Re: **Submissions on PC7 – McIntosh, Jung and Lee; and Denwood Trustees Ltd**

**SUBMISSION ON PLAN CHANGE 7 TO THE SELWYN DISTRICT PLAN –
VOLUME 2, RURAL SECTION**

McIntosh, Jung, Jung + Lee 2007 Consents: Original
Amended Subdivision Plans

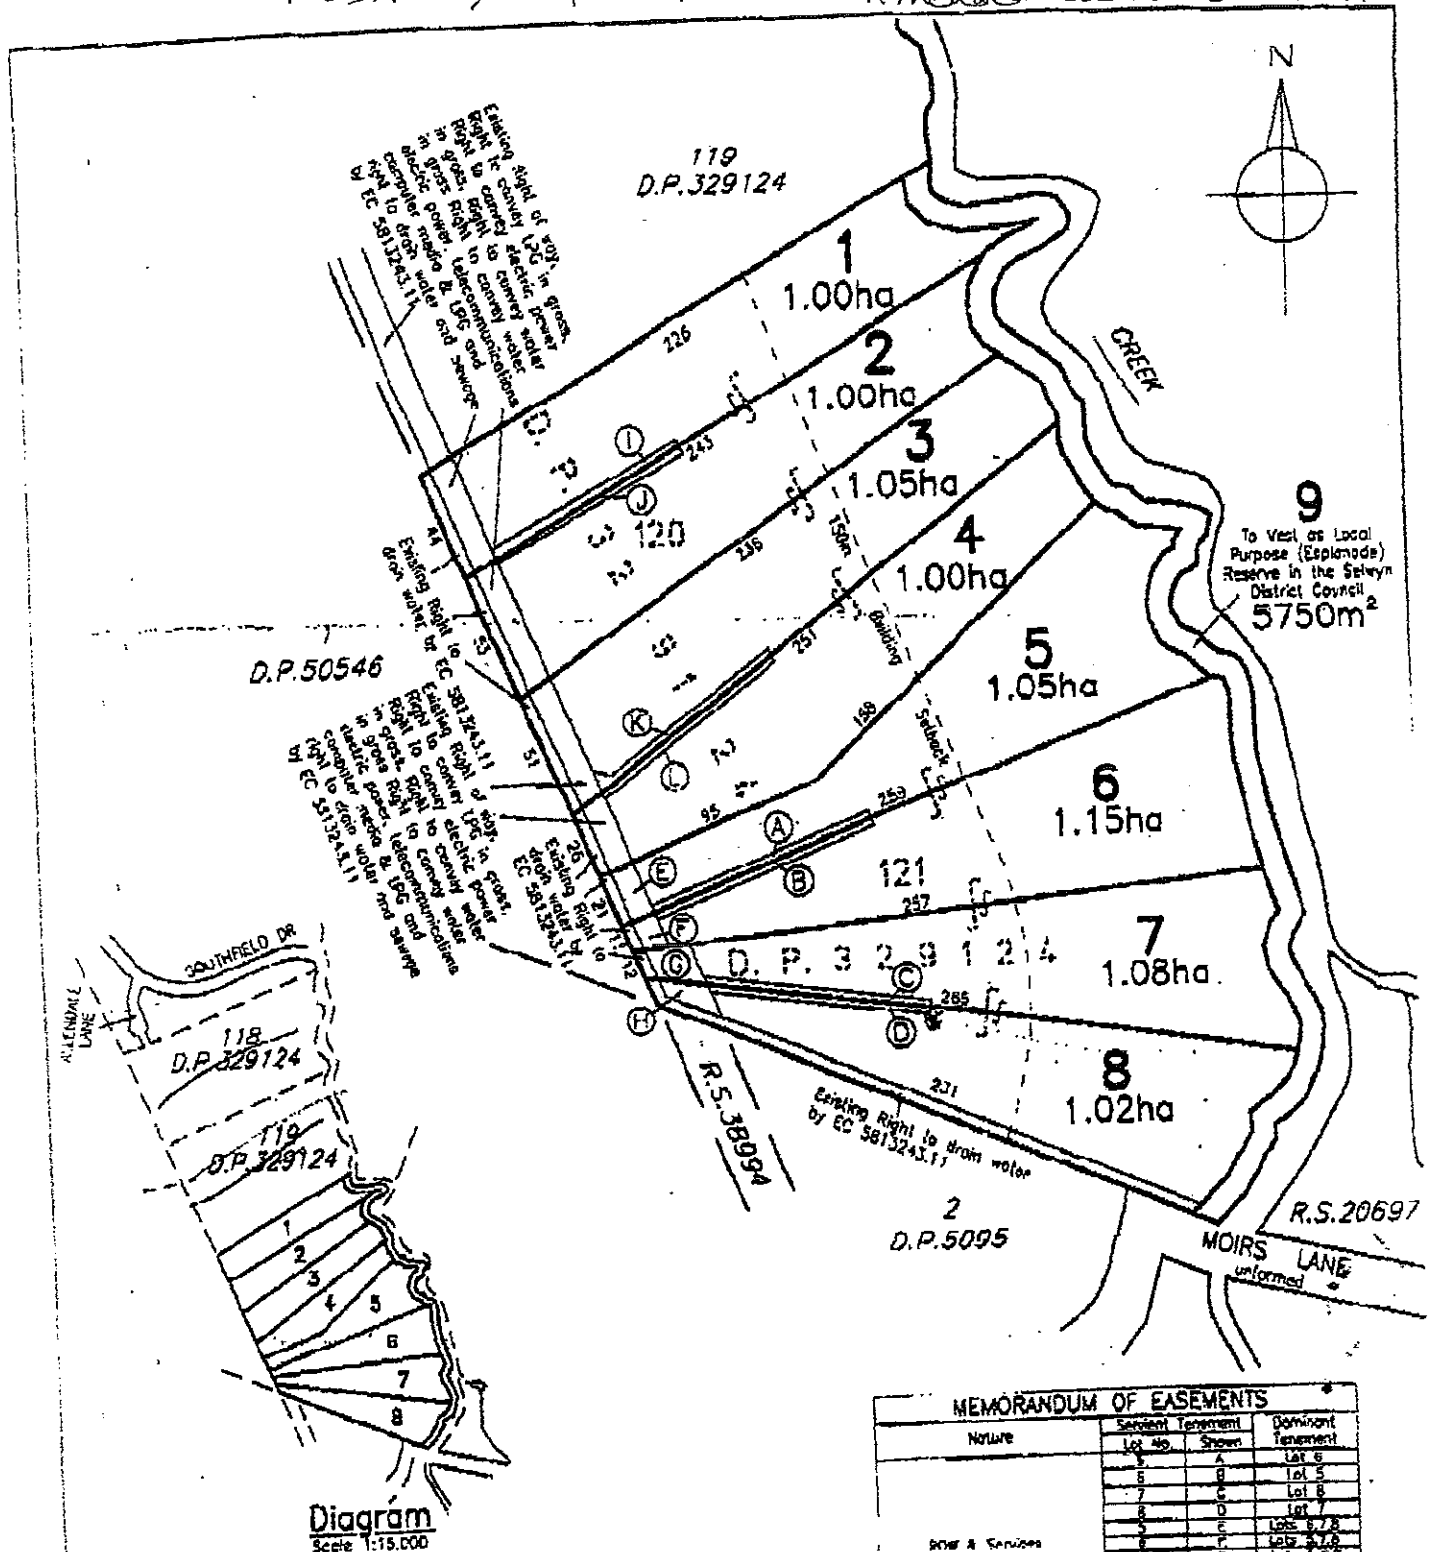
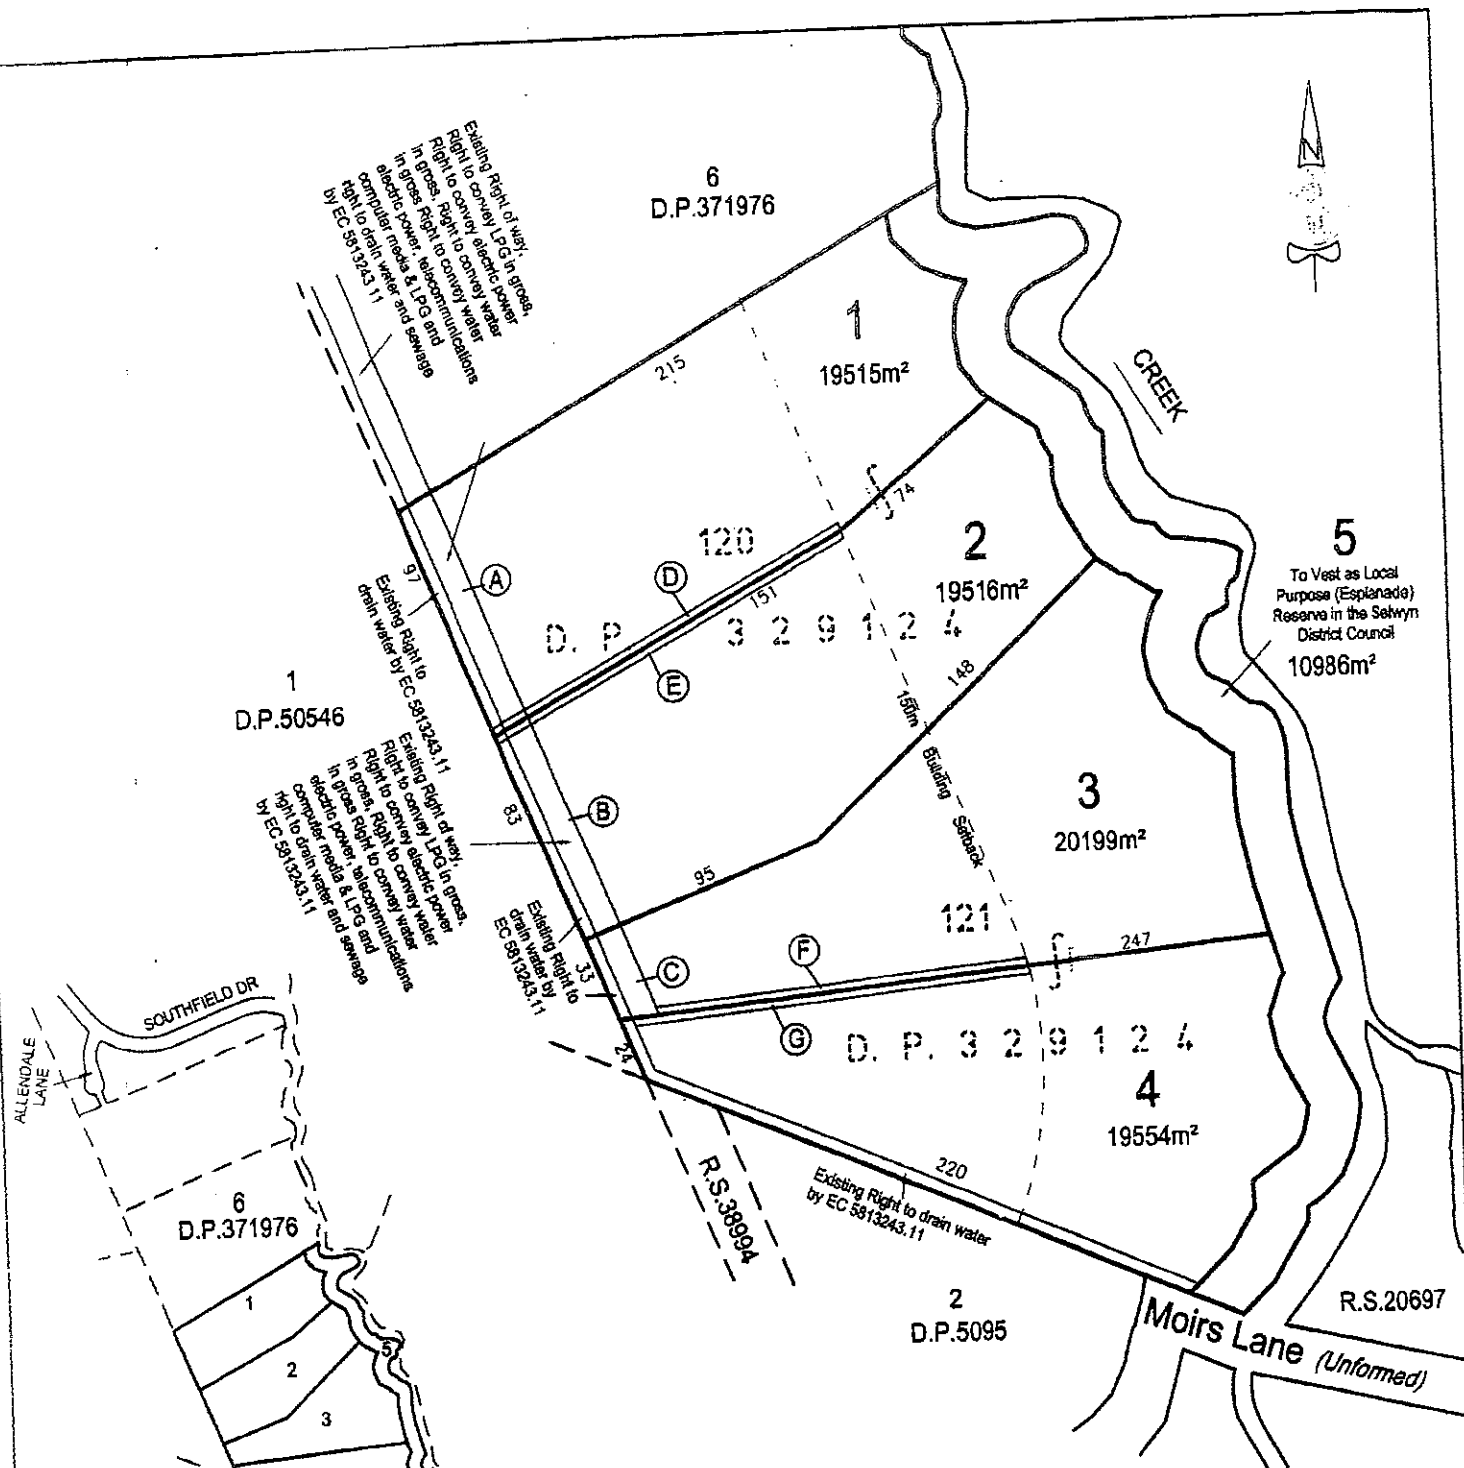
In 2007 we applied for a resource consent to subdivide our two properties into a total of 8 x 1 ha lots, each with a dwelling. Land immediately to the north had been subdivided into 4 x 1

ha lots and 2 x 2 ha lots in 2005. Prior to the hearing, we amended our proposal by reducing the number of proposed lots to 4 x 2 ha lots. Copies of the original and amended subdivision plans are attached as Attachment B.

Amendments Sought to ODP Area 1

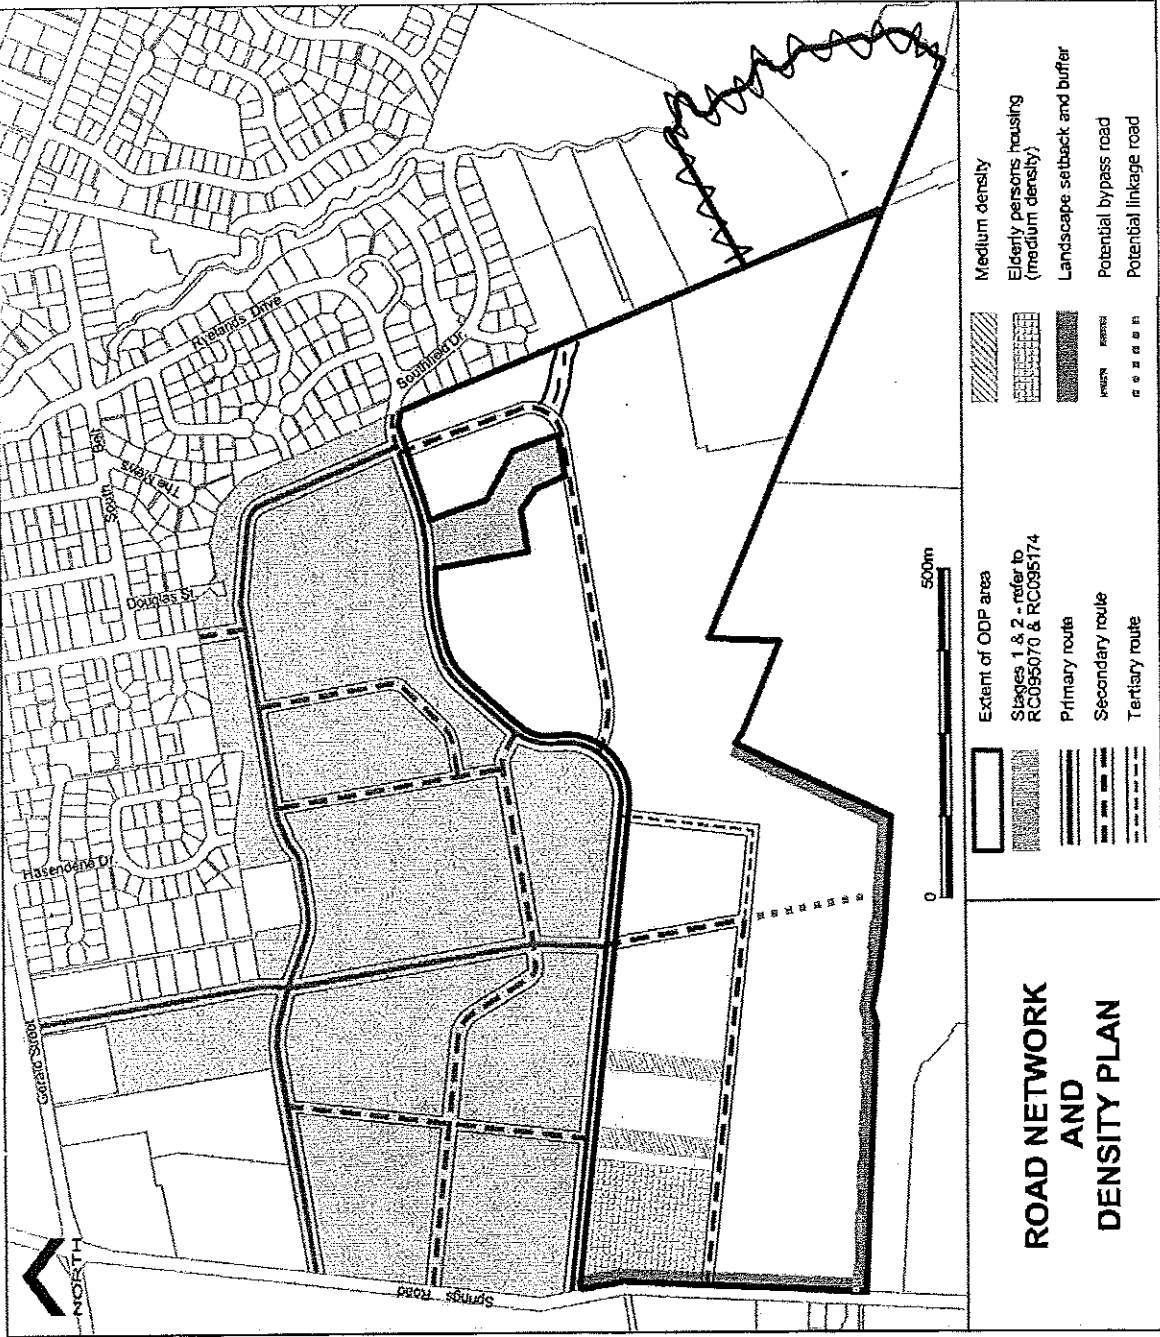
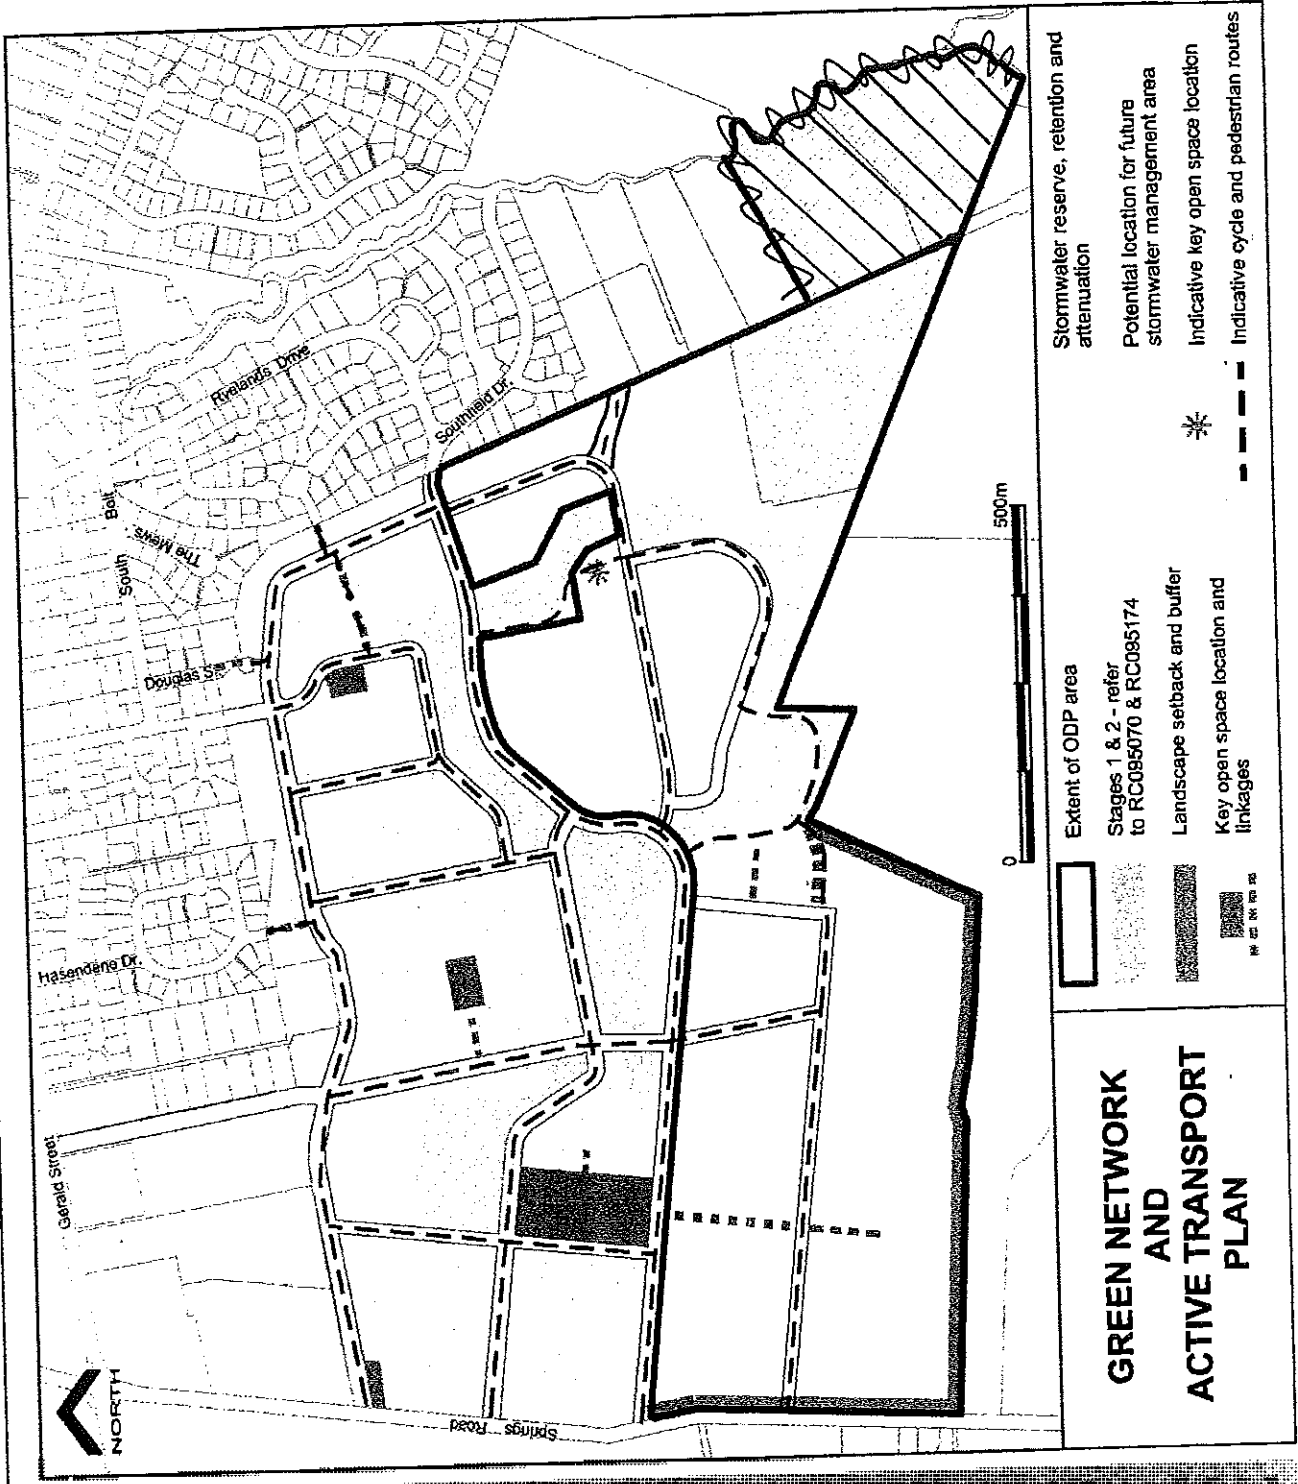
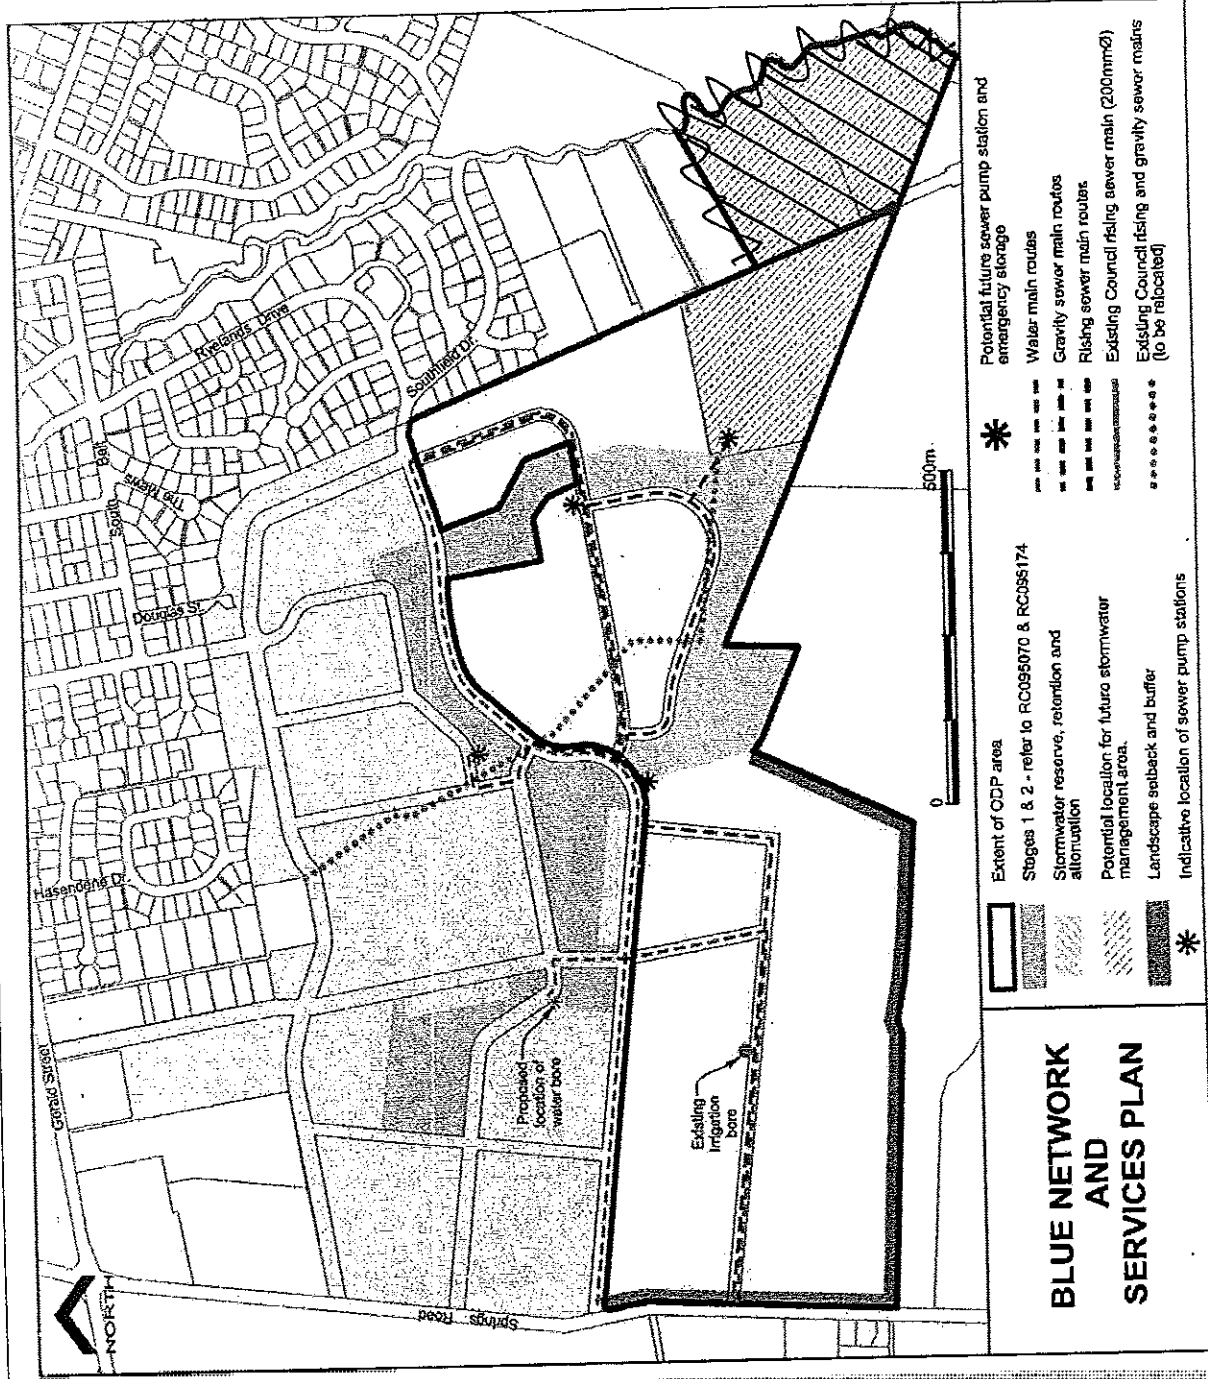
- Delete the notation 'potential stormwater management area' over our land and amend the area of ODP 1 to exclude our land.
- Delete 'Maintenance of the buffer zone (150m) around the perimeter of the sewerage treatment plant'. This is to be decommissioned so is unnecessary and should be removed.
- Amend bullet point 5 to read:-
'Provision of a comprehensive stormwater/wetland system, including stormwater wetland areas where required to accommodate necessary flows, in accordance with approved stormwater discharge consents, and based on mitigation of stormwater effects within the ODP 1 Area.'
- Amend ODP 1 to show a roading link to the boundary of our land, or as a less preferred alternative, to the boundary of the existing rural lifestyle blocks to the north of our land (as per amended ODP Area 1 attached as Appendix D).

*W Delete from ODP Area 1
 Remove status as part of 'potential location for stormwater management area'.*

Remove status as part of 'potential location for stormwater management area'
